REV.  
D

AS4309

FITTING, NIPPLE, FLARED TUBE TO PIPE THREAD, FOR SEAL RING

FIGURE 1 - FITTING, NIPPLE, FLARED TUBE TO PIPE THREAD

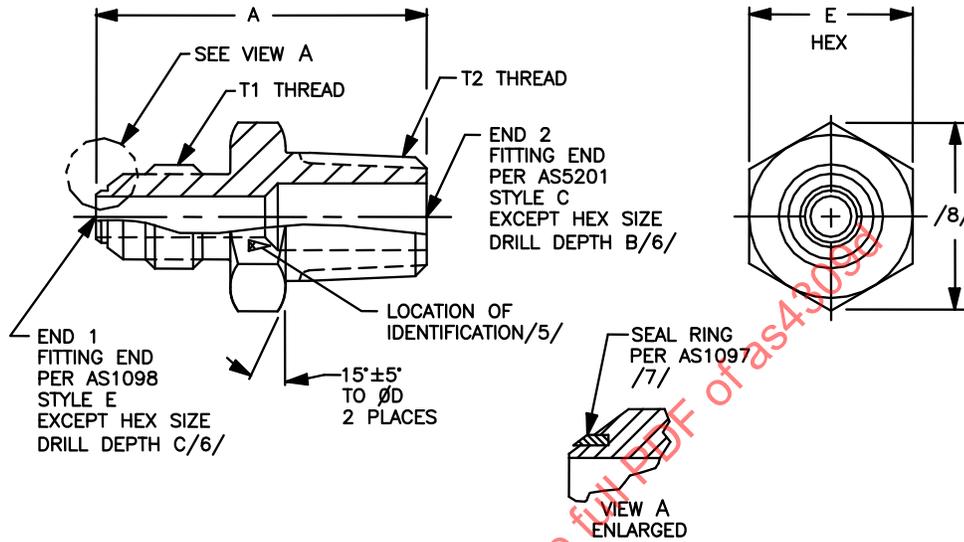
CORRECTED END 1 TO STYLE "E" IN FIGURE 1. UPDATED NOTE /4/ TO DELETE "PRI" STATEMENT AND CORRECT THE NADCAP SCOPE TO AC7112, AC7112/2 ADDED USAGE/CAUTIONARY STATEMENT TO NOTE /1A/.
